# Maine Yankee

Proposed Change No. 218, Supplement 17

**Subject: Response to NRC RAI on FSS Final Report No. 5**

**Maine Yankee Response to NRC Request for Additional Information (RAI) Regarding  
Final Status Survey (FSS) Final Report No. 5**

Map#: MSC-001    Date: 4-28-04    Time: 1115    Reactor Pwr %: N/A    Tech File Number: 11500.5    RWP's Used: ~~11500.7~~ N/A    Dose Received: 0 mR

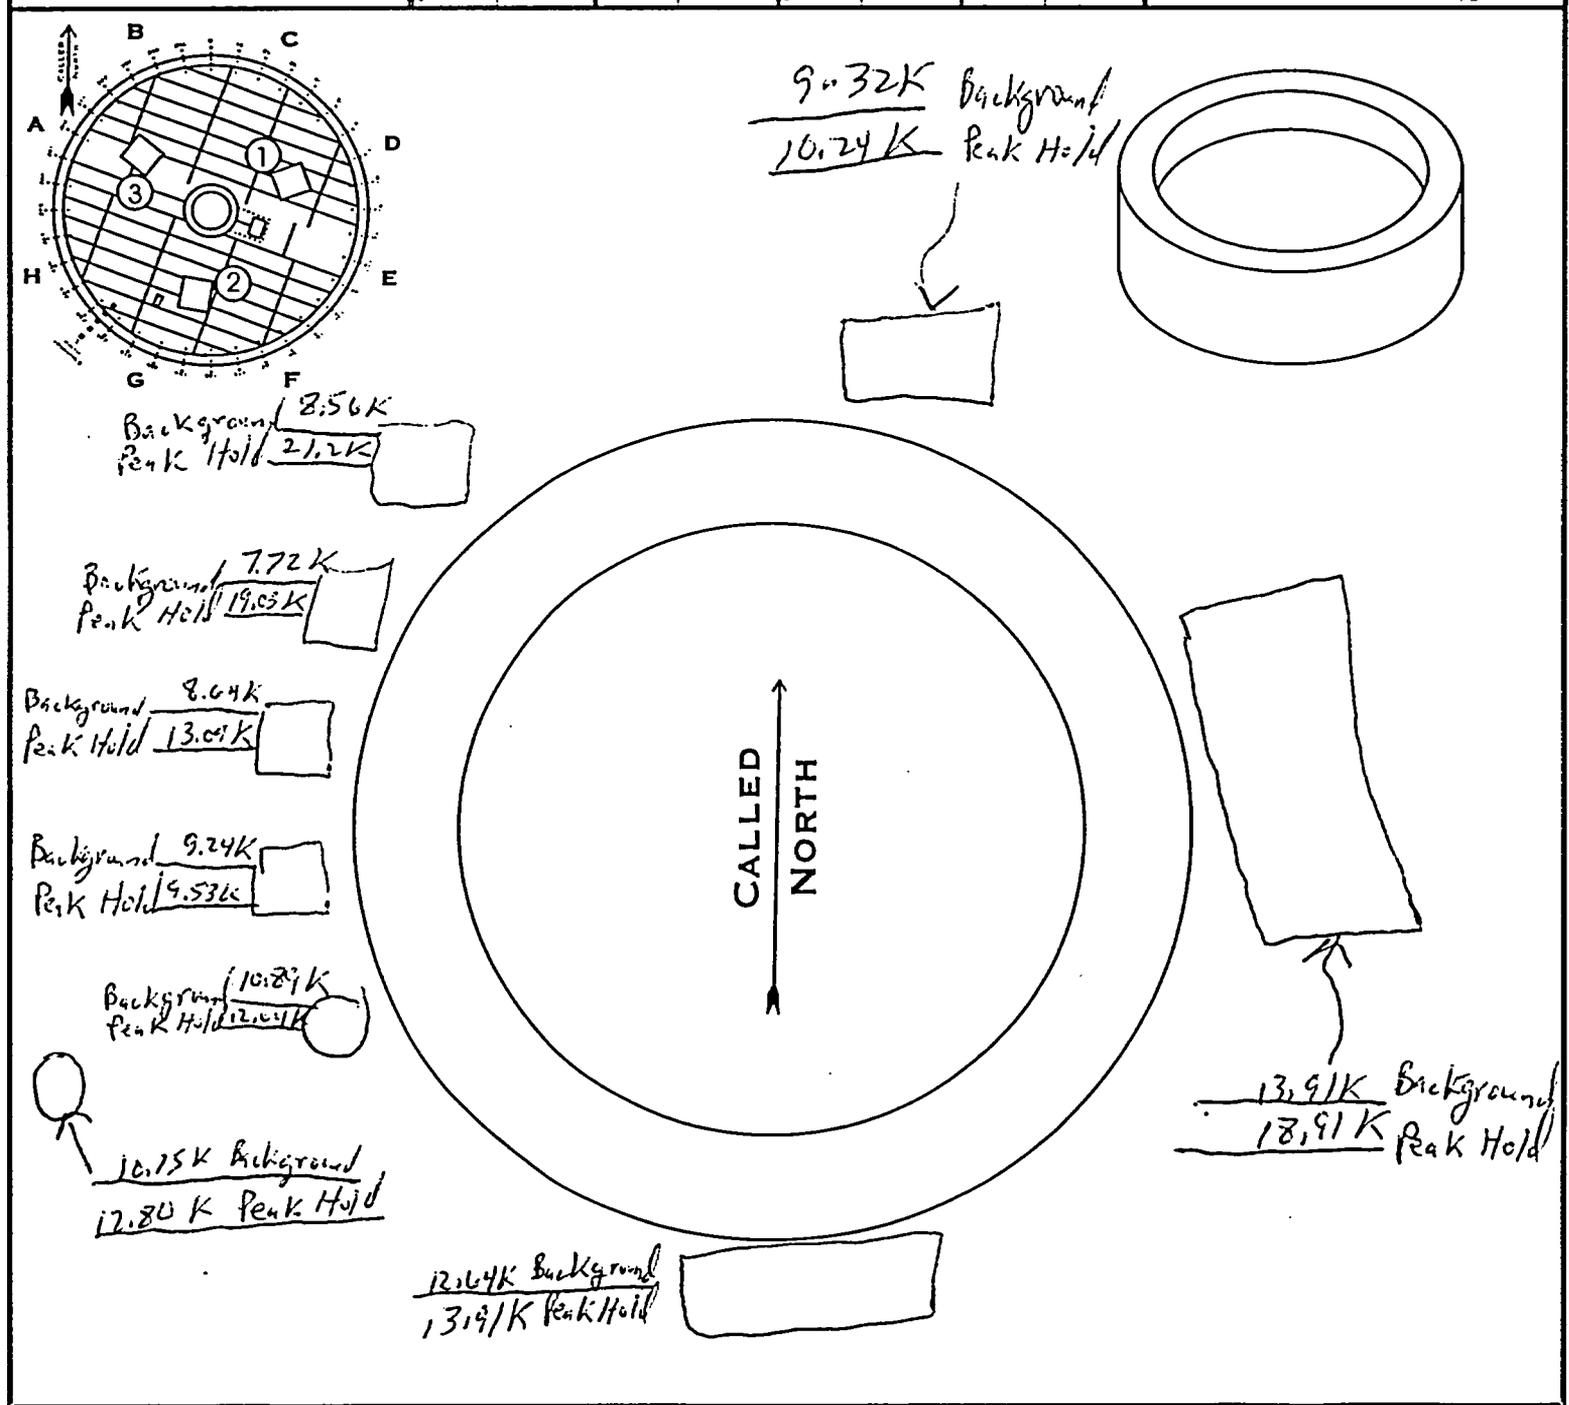
*FSS - Release Record FA-0100 Survey Unit 2 is a Class 1 area. LTP Section 5.4.1 requires the performance of 100% Scan Survey for Class 1 areas in accordance with MARSSIM. In addition, LTP Section 5.5.1 (a & d) require sampling or surveys to determine contamination at depth. During the May 24-27 site inspection, the staff observed large deep holes in the floors principally near the pedestals, where the flow-able concrete placed during original plant construction left voids. In addition, the staff noted that in some areas the metal liner was missing and the floor was bare concrete. The holes in the floor are not mentioned in the release record nor is survey information provided that specifically corresponds to these configuration anomalies. Please provide survey data to demonstrate these areas were scanned to comply with the 100% scan requirement.*

*In addition, the staff observed significant quantities of water on the containment floor which required a significant effort by Maine Yankee to dry prior to performing FSS's of floor surfaces. Given the influx of water onto the containment floor and observing the water under the steel liner, the potential for migration of contamination existed. Please provide (gamma) surveys of the areas (either in conjunction with the FSS or from the Remediation Phase) that demonstrate that no significant contamination at depth was present under the metal liner.*

**Maine Yankee Response:** Holes were made in the steel liner as a consequence of the removal of all concrete from the Containment floors down to the liner. The holes were not a pre-existing condition. In order to ensure that the underlying concrete did not become contaminated to significant levels, the exposed area beneath the liner was checked. The larger holes were surveyed by SPA-3 and 43-68 for signs of elevated activity. Concrete samples were taken and analyzed using the same criteria as previous sub-surface samples. Results of 74 floor and sub-liner SPA-3 measurements were all less than 30,000 c/m. The concrete samples were all less than the 37 pCi/g criteria for 1 cm depth of concrete (the maximum value was 19.2 pCi/g). These survey results demonstrate that no significant contamination at depth is present under the metal liner.

Attached (Appendix A) are the gamma scan results of the Containment Building liner holes.
